23 Grafton Street
Chevy Chase H.D.

From: Bourke, Tom (Winchester Homes, Inc.)(Tom) [tom.bourke@whihomes.com]
Sent: Wednesday, July 27, 2011 3:56 PM
To: Fothergill, Anne; Manarolla, Kevin; Whipple, Scott; Silver, Joshua
Cc: ChCh Village file (CCV@montgomerycountymd.gov); Feldman, Gail; HBSacks@comcast.net; Jacobs - Eph's daughter (abjdoe@gmail.com); Marsh, Joan (r.marshes@gmail.com); P. Wellington; Stephens, Betsy
Subject: HPC Hearing for 7/27/11 - 7 Newlands; 8 Grafton; 23 Grafton

MONTGOMERY COUNTY HISTORIC PRESERVATION COMMISSION
STAFF REPORT

Address:	23 Grafton Street, Chevy Chase	Meeting Date:	7/27/11
Resource:	Contributing Resource Chevy Chase Village Historic District	Report Date:	7/20/11
Applicant:	Richard and Amy Zantzing (Chris Snowber, Architect)	Public Notice:	7/13/11
Review:	HAWP	Tax Credit:	None
Case Number:	RETROACTIVE 35/13-10Y REVISION	Staff:	Anne Fothergill
PROPOSAL: Front dormer window replacement

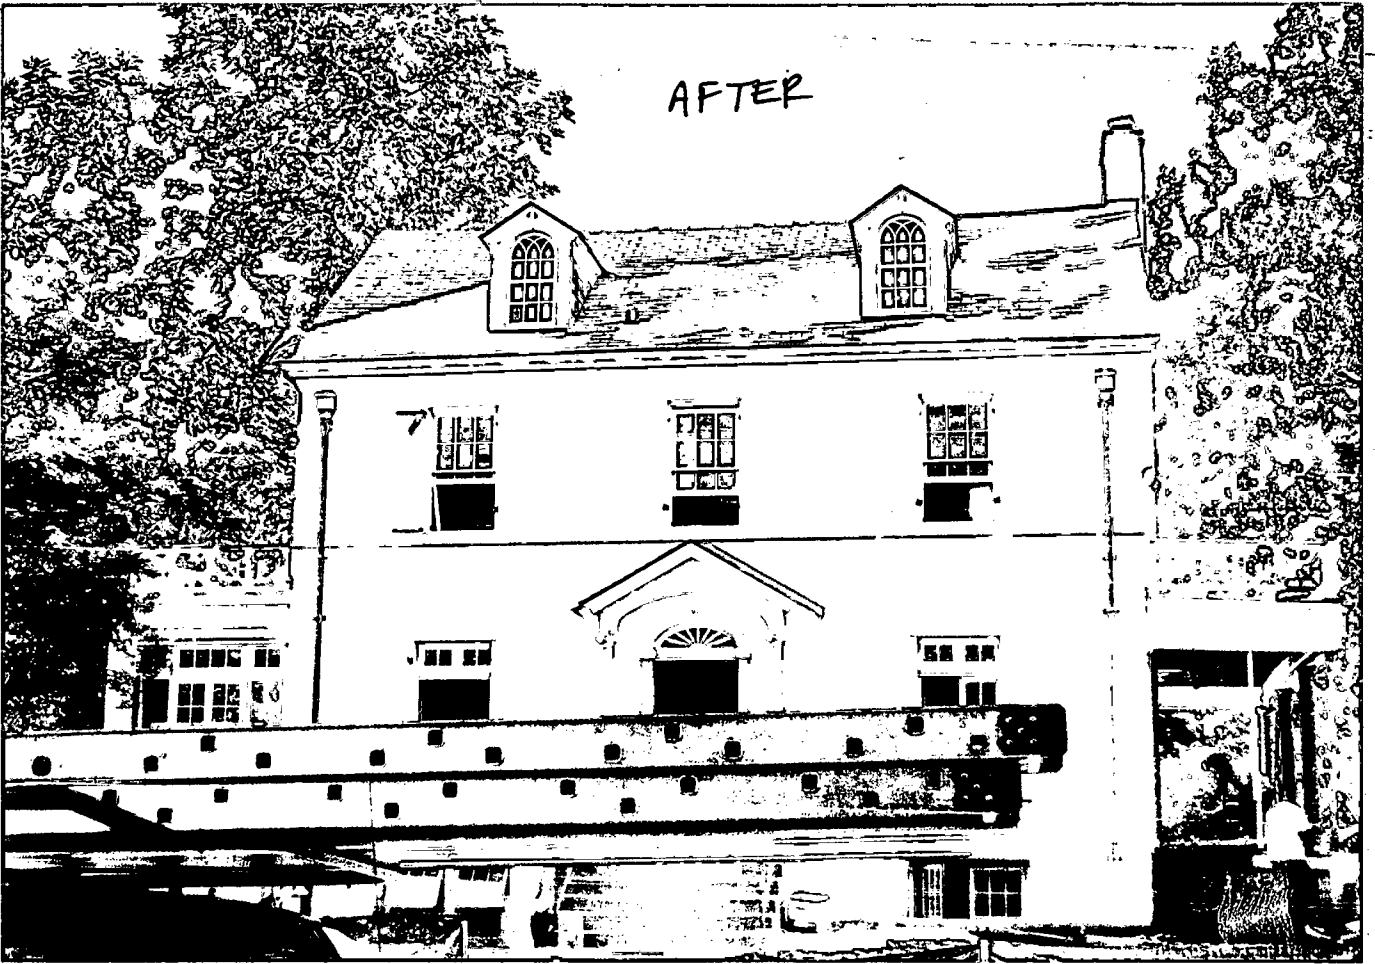
The LAP agrees with staff that having to do a retroactive approval is "very unfortunate", and the LAP does not condone replacing windows without a HAWP. However, given the circumstances we would urge leniency as staff and HPC review the proposal. It would appear to us that the applicant had followed all procedures for approvals of initial alterations for the home renovation, but then had to make this modification for fire code egress and did not resubmit. Staff acknowledged that the new windows were installed in the original frames and "are wood windows with a muntin pattern and trim that matches the original windows. It will be difficult to distinguish the window detailing since they are on the 3rd floor, and the Commission might find it reasonable to have new windows with an overall appearance of the original windows in this high location."

LAP agrees that this is entirely reasonable and good solution for a house which must be a functioning residence.

Dormer Window

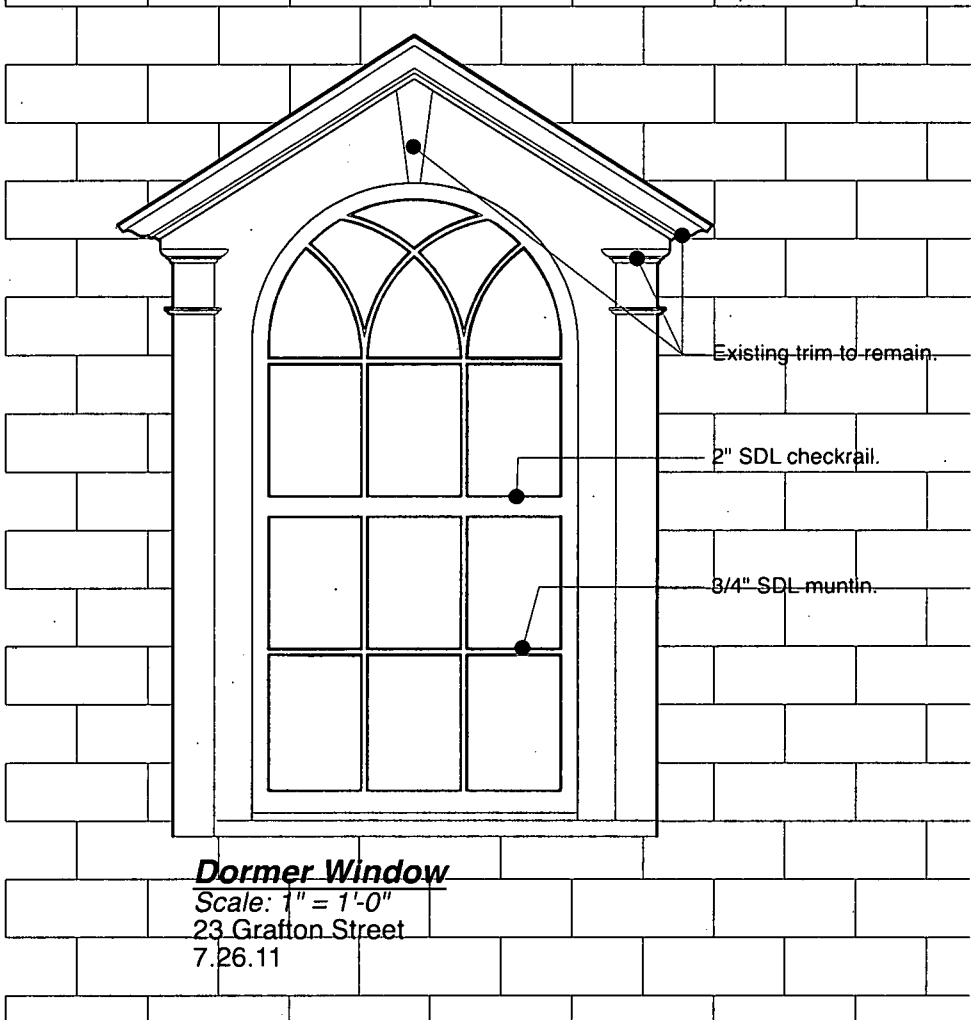
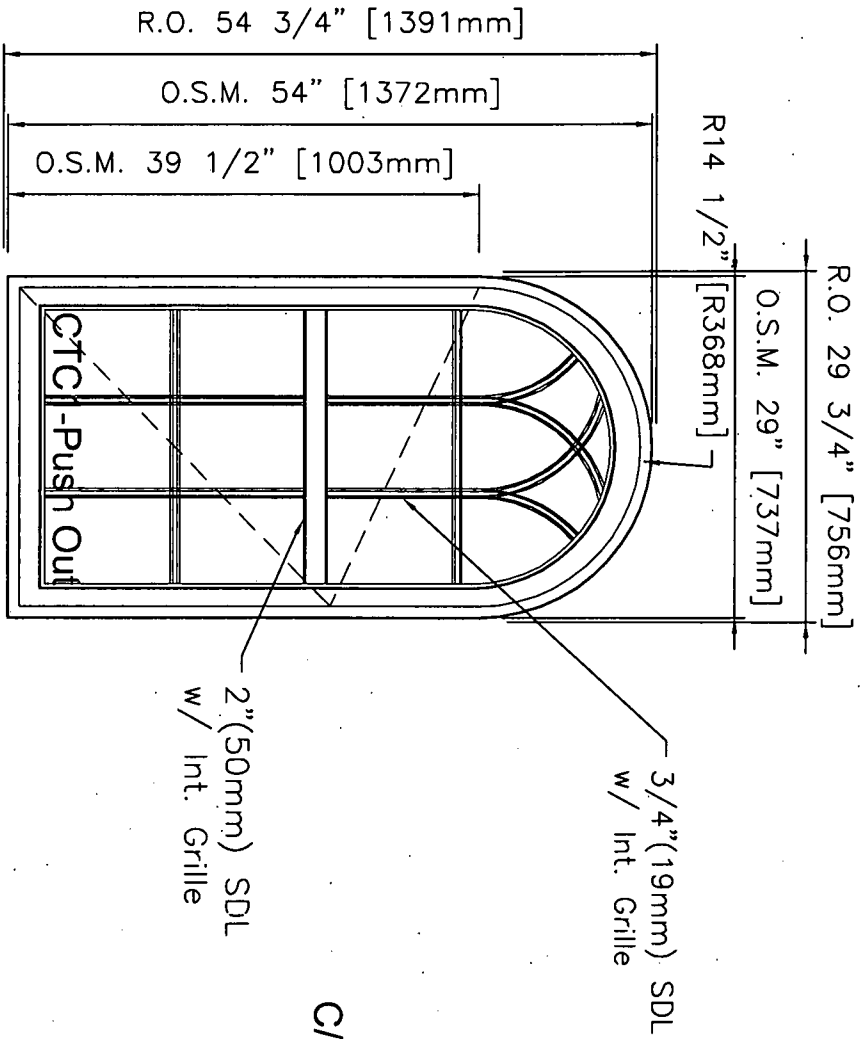
The applicants are proposing to replace two double hung windows in the front dormers with wood casement windows in the existing openings with the same muntin pattern in simulated divided lights. The existing trim will remain. The existing windows are in deteriorated condition and the applicants are planning to use the attic space for bedrooms and need the casement windows to meet Code for egress.

The dormer windows may have been deteriorated as the applicant states but generally the HPC requires the repair of original windows whenever possible and we are unable to determine if in fact these windows could have been repaired.

In this case, the replacement windows were installed in the original openings and are wood windows with a muntin pattern and trim that matches the original windows. It will be difficult to distinguish the window detailing since they are on the 3rd floor, and the Commission may find that it is reasonable to have new windows with an overall appearance of the original windows in this high location. Staff will provide the Commission before and after photos showing the dormers prior to the meeting (photos will be sent electronically for better clarity and comparison).

The Commission has infrequently allowed replacement of double hung windows with casements to meet code for egress on a case-by-case basis but only after a discussion with the applicants about other possible solutions and window replacement in less prominent locations. Looking at the plans it might be possible to install the egress windows on the side elevations. This would require enlarging the existing half round window openings in the gable ends on both sides (staff notes that an egress window might not fit on the east side because of an existing chimney). The HPC recently approved a similar alteration on a contributing resource in the same historic district. It is possible that the HPC would consider that option as a solution that would have less impact on this house than removing original windows on the front façade. But the Commission may find that retaining the original openings on the front and sides of the house is more in keeping with the *Guidelines*.

Staff recommends that the Commission **continue** the HAWP application.

1 Proposed South (Grafton Street) Elevation
Scale: 1/4" = 1'-0"

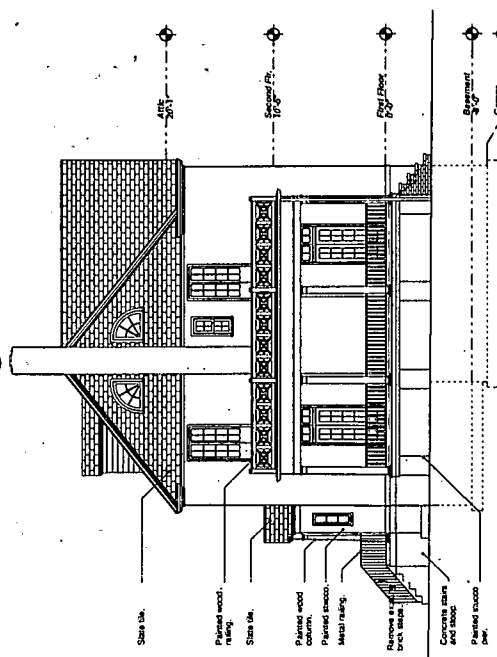
I am writing today to propose a revision to the two front (south) dormer windows at 23 Grafton Street, shown on the attached HPC submission and permit drawings.

1. Inspection of the windows indicated that the windows were in a condition beyond repair, with extensive rot due to water damage to the sills, sashes and frames and failed glazing putty leading to muntin damage.
2. The existing double-hung windows did not meet code for egress from a bedroom, (the existing and proposed use of the space), as neither the lower or upper sash was large enough to meet the minimum opening size requirement. The two windows on the east and west sides of the attic are not of sufficient size for egress, either.

Considering these two conditions, we discovered that a single casement window would be large enough meet egress requirements. We then designed a painted wood window would that matched the existing in muntin pattern and detail, including a check rail of matching dimensions. While the window sash and frames were replaced, the existing exterior trim was called out to remain. (See attached existing and proposed window drawings).

We are requesting that the HPC approve the replacement of these two windows. If you have any further questions, please feel free to contact me.

Proposed Garage Elevations

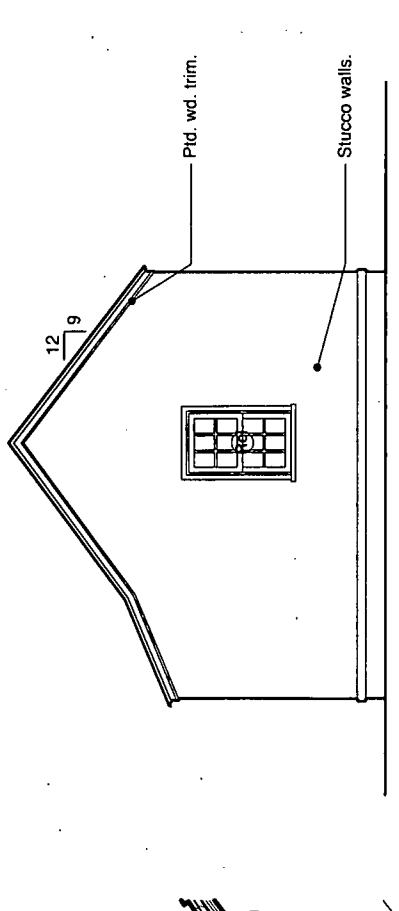
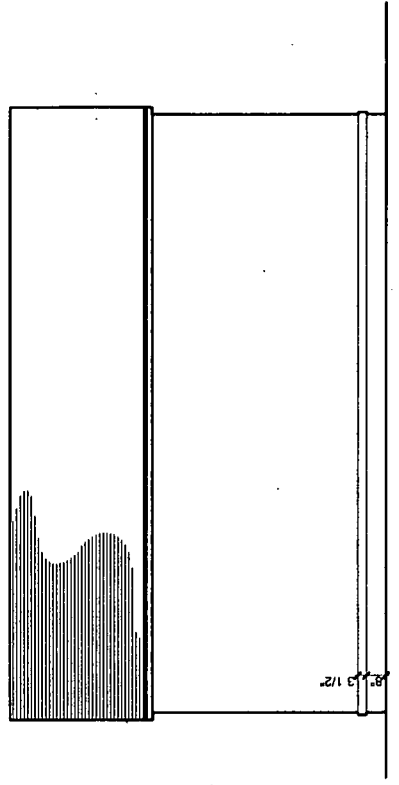
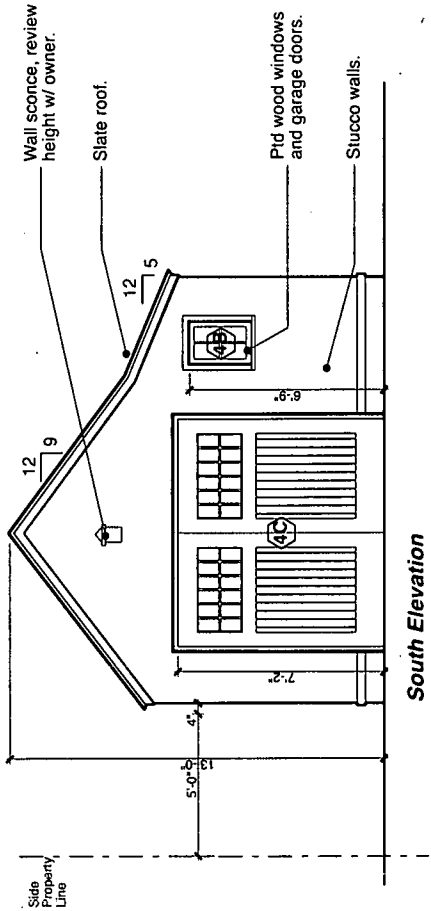
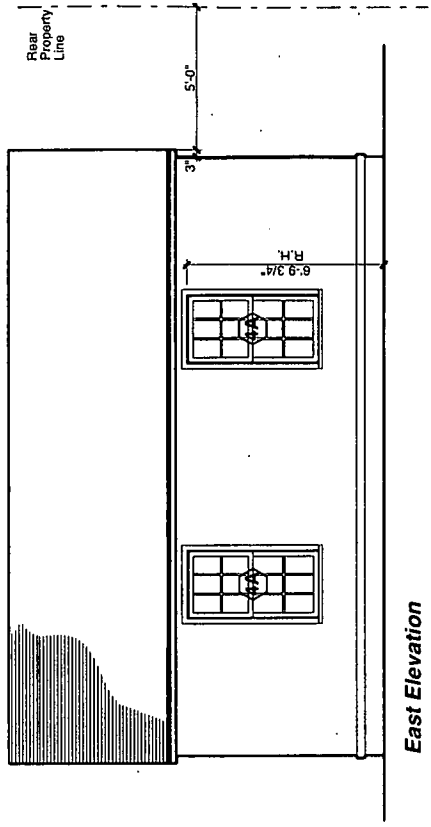
1. North Elevation: Add window. West Elevation: Delete two windows.

Reason for changes: The owners needed hanging storage on the side of the garage that the two windows would prevent. They also felt there was a security risk. The windows that we are proposing to delete are on the side of the garage which is 5'-0" away from a 7'-0" high fence on the property line. The window at the rear is to add some light taken away by the loss of windows on the side.

2. East and West Elevation: Delete gutters and downspouts.

Reason for changes: During construction, our surveyor incorrectly laid out the building, and placed it 6" closer to the property line than it should have been (5'-4" rather than 5'-10"). Our proposal is to delete the gutters and downspouts and revise the depths of the overhang to be 4", so that the face of the overhangs is 5'-0" from the side property line. As you probably know, the Village of Chevy Chase measures buildings to the overhangs, not the face of the building.

Proposed East Elevation

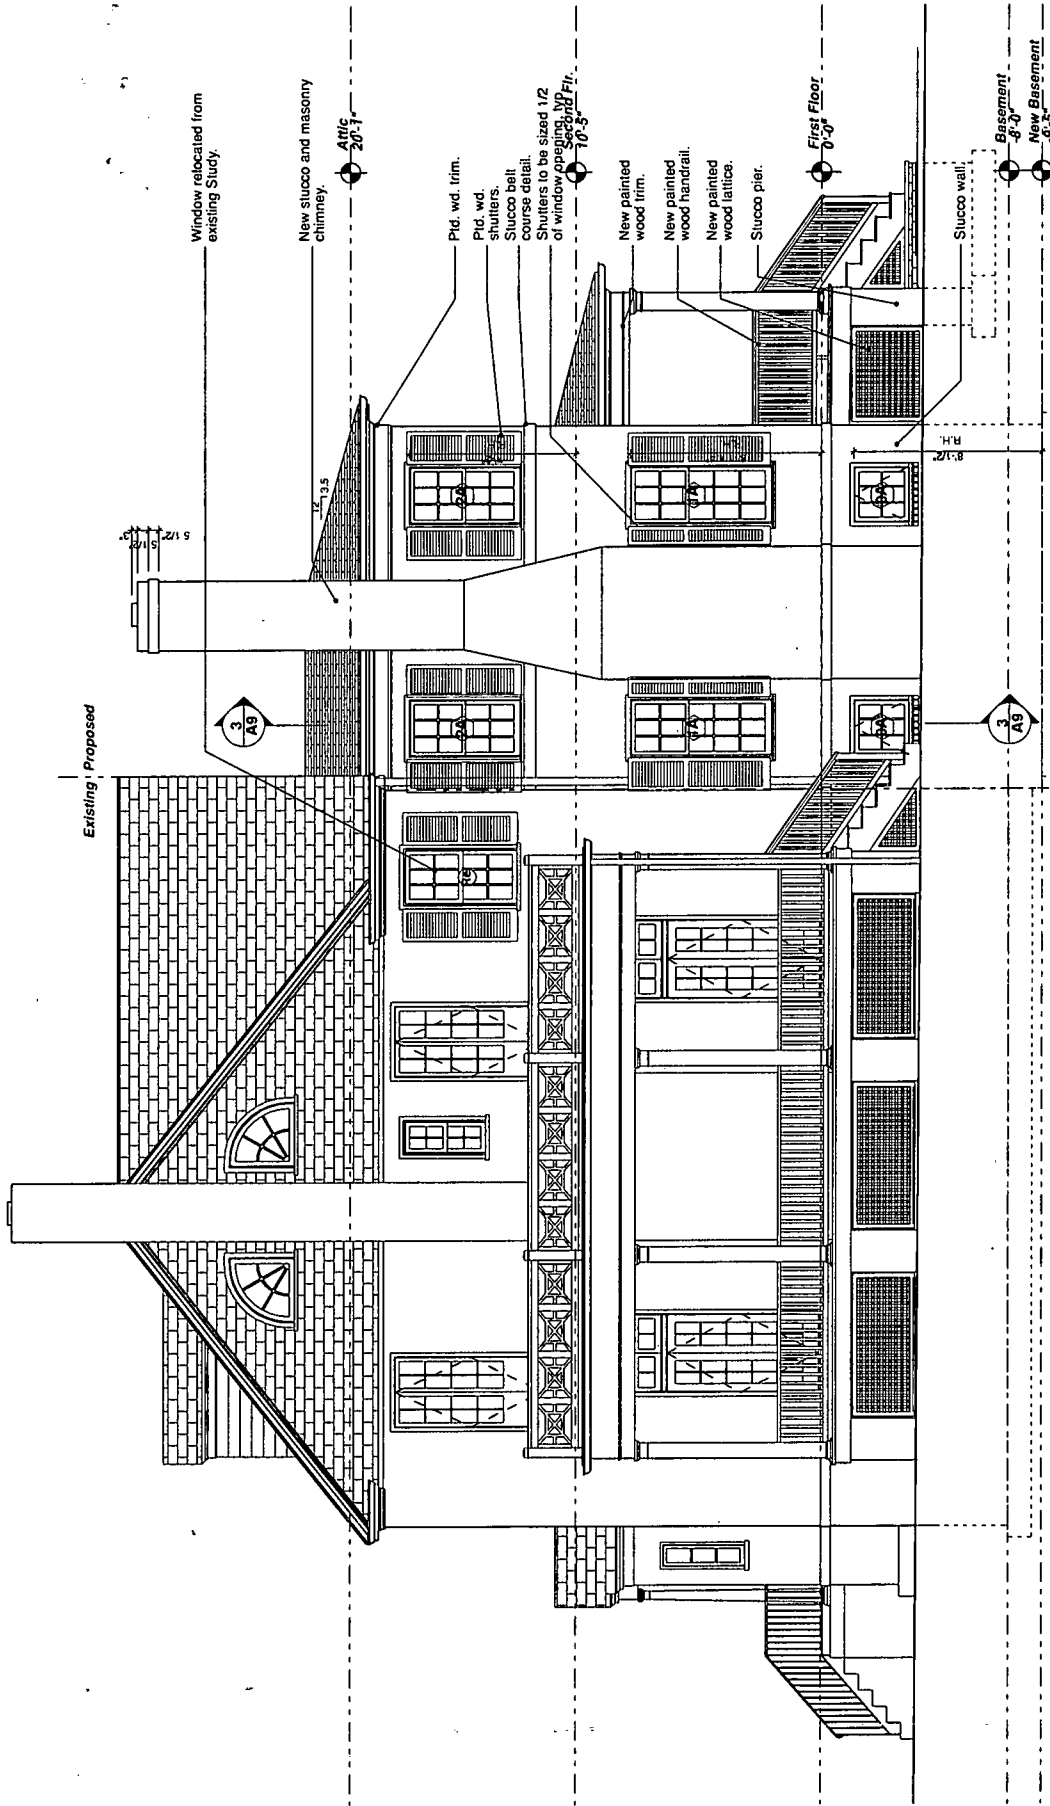
4. East Elevation: Add new window at second floor NE corner bedroom, to the right of the doors to the right of the chimney, just above the porch railing. The window would matching existing windows on house, and mirror a similar window on west elevation.

Reason for change: This bedroom lost a window on the rear due to the new addition, and now that we are under construction we see how dark the room is with just one window. The proposed window would add more light to the room.

This is a staff item for discussion at Wednesday's worksession. 23 Grafton Street is a contributing resource in the Chevy Chase Village HD. The HPC recently approved a rear addition to the house and construction of a new garage behind the house. The owners' architect has listed below their proposed changes and attached are the approved and revised (proposed) plans. Staff recommends approval of items 1, 2, and 3 but not 4 because it is a new window opening in the historic block.
